T18SZ SOFTWARE UPDATE CHANGES

V2.0

This software updates or alters the functions and features noted below. The instructions and information that follow are meant as a supplement to the original instruction manual that accompanied the T18SZ transmitter. Please refer to the original instruction manual where applicable, but replace the steps indicated below with these instructions. Please check to ensure that the update has been installed.

1.Vario Melody Setting

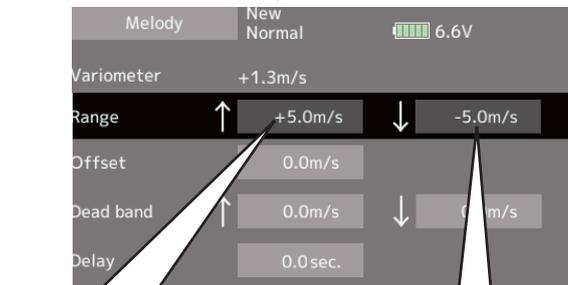
Vario Melody Setting is added to the variometer of the Altitude Sensor and GPS sensor.

2.Telemetry Alarm Duration and Repeat time

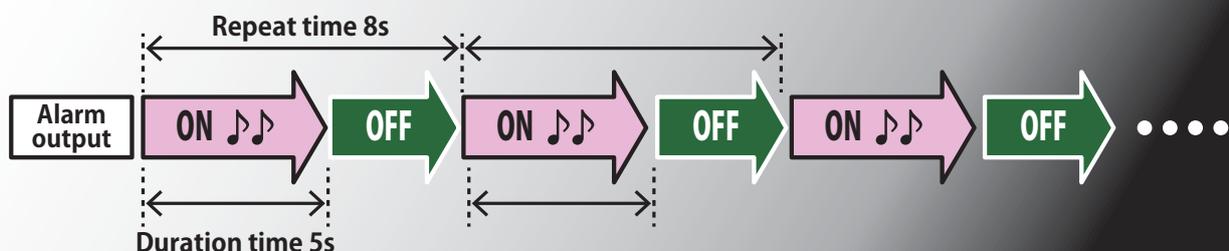
The repeat time and duration time for the telemetry alarm (buzzer, vibration and speech) can be set.

Duration
It is an alarm output time.
Setting range：1 s ～ 30 s
Initial value：INH
Duration value has to be less than repeat value.
Duration time is extended when the other alarm event occurs.

◆ Linear・Hysteresis mode

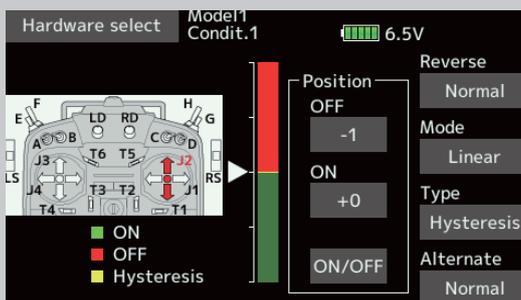
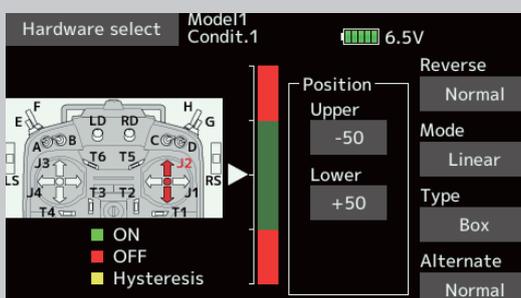
This setting method selects function ON/OFF based on the set point. Hysteresis (dead band) can be set to ON and OFF. The ON and OFF positions can be reversed with the Reverse button.

◆ Symmetry・Hysteresis mode

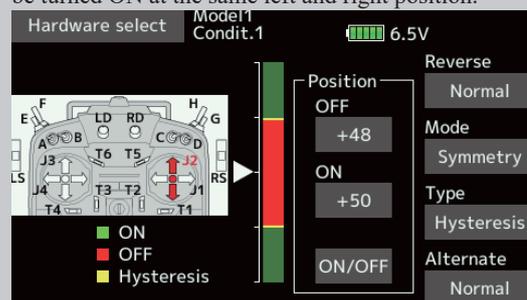
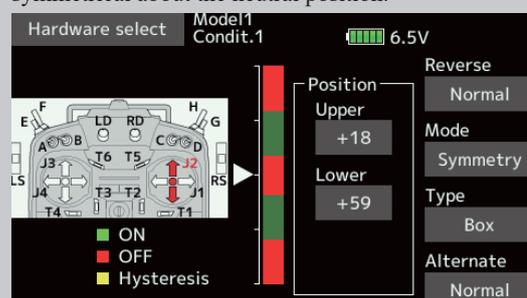
The operation is the same as the linear hysteresis mode, but left and right (up and down operations are symmetrical about the neutral position. For example, when you want to switch DR1 with the aileron stick, when the stick is moved to the left or right, DR1 can be turned ON at the same left and right position.

1. Curve setting operation

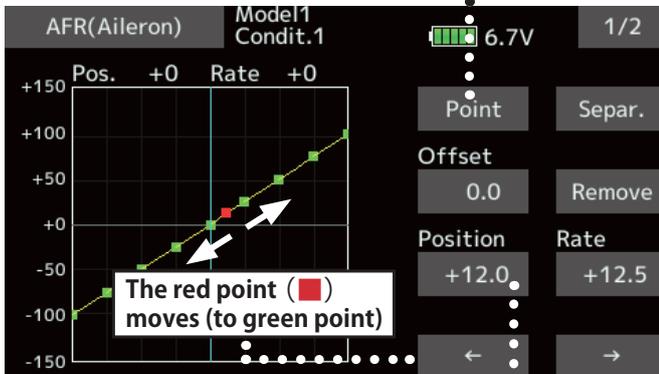
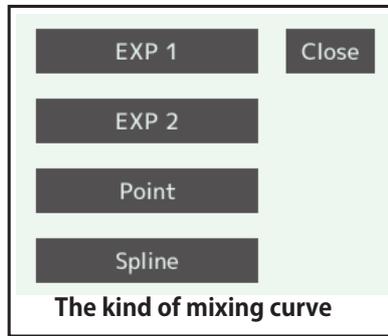
Point curves or spline curves of up to 11/17 points can be used. (Initial value: 11/9 points) **The set points can be freely increased,** decreased, and offset.

3. SBS-01C current sensor function

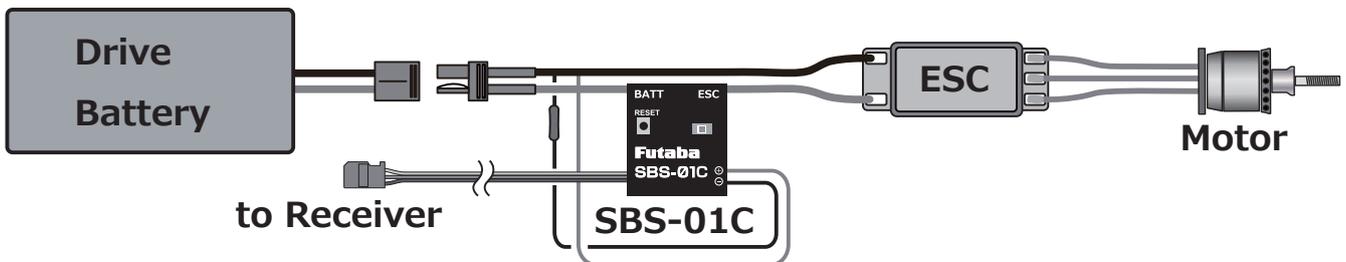
The T18SZ has been made compatible with the SBS-01C current sensor. The SBS-01C has the capability of measuring current, voltage and capacity (consumption) from drive battery at the same time.

5. Stick mode

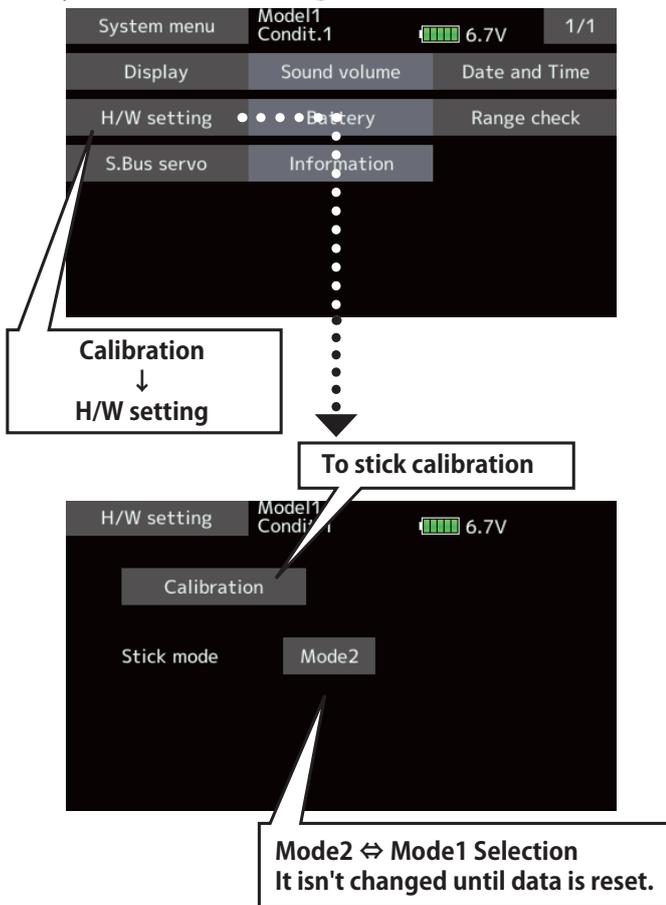
Addition of stick mode function.

Mode 2 or Mode 1 can be chosen.

But, it isn't changed until data is reset.

To change the mode the stick ratchet must be changed. Request that this be done by Futaba Service. (Charged modification)

6. Throttle stick position alarm
< Airplane/Glider >

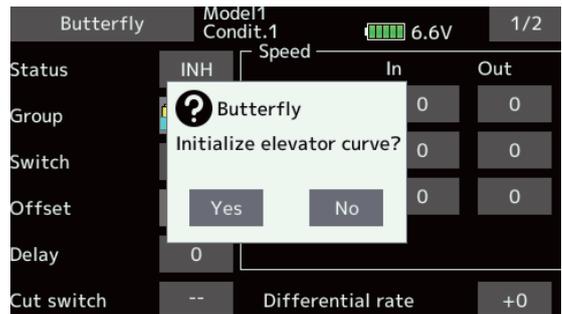
When the old version makes the function of the throttle stick a motor, a throttle stick position alarm has not started.

When the new version makes the function of the throttle stick a motor, a throttle stick position alarm has started.
